**Project No. IFB 18-30**

HVAC Chiller, Boiler Systems & Associated Equipment Replacement (LoanSTAR #2)  
HCC Spring Branch Campus

**Addendum #1**

**Addendum #2**

# 01 UNDERGROUND CHW PIPE TRENCH DETAIL

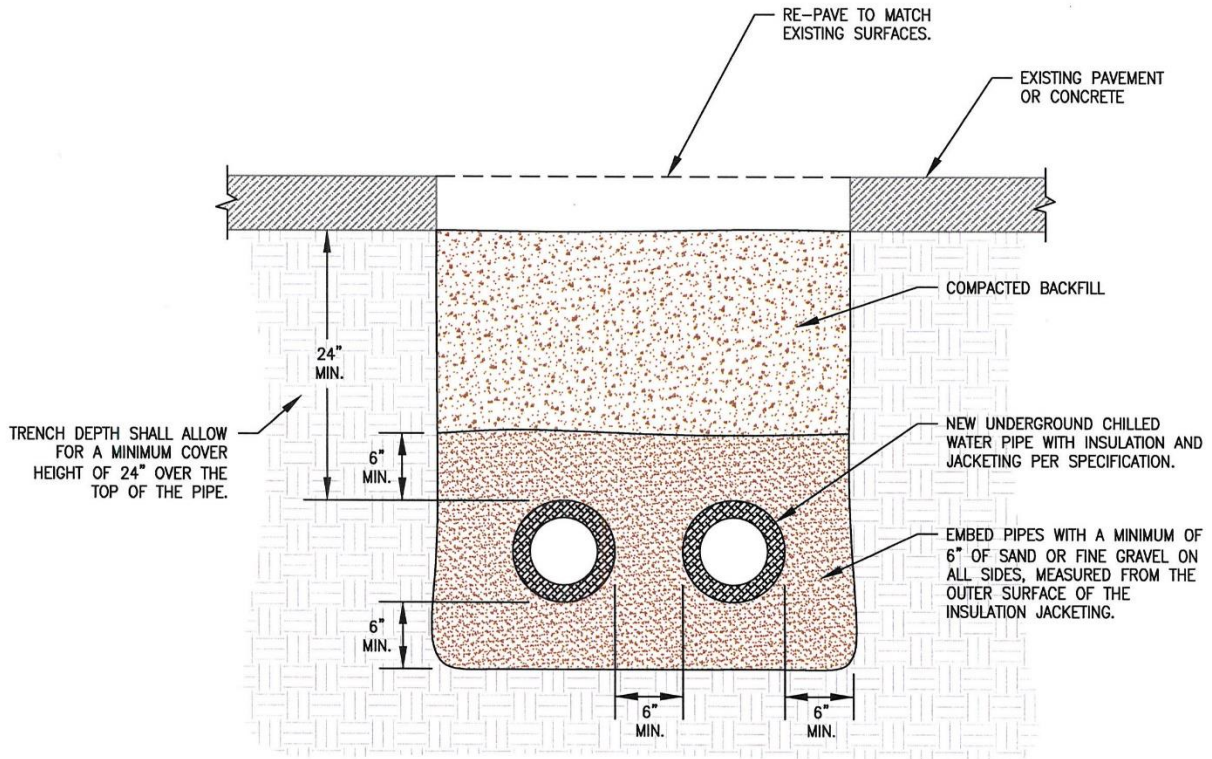
**Q8.** Can we get a detail drawing on the trench that shows the pipe depth, backfill, select fill and asphalt or concrete (at parking & roadways)??

**Q9.** What will the minimum depth of the trench for the underground piping need to be? Soil compaction requirements? Can we use the spoils to bed and refill the trench or will we need to use select fill. If select fill, what should be used?

**Response:** Please refer to the Pipe Trench Detail attached at the end of these questions.

**Response:** Please refer to the Pipe Trench Detail attached at the end of these questions. Trench and backfill to be designed for H-20 loading and in accordance with the pipe manufacturer's instructions. Provide select fill for trenches through paved areas. Refer to Section 3.8 "Excavation and Back-Filling" in Specification 23 05 00 "Mechanical General Provisions".

NOTE: MAINTAIN 24" SEPARATION FROM OTHER UNDERGROUND UTILITIES.
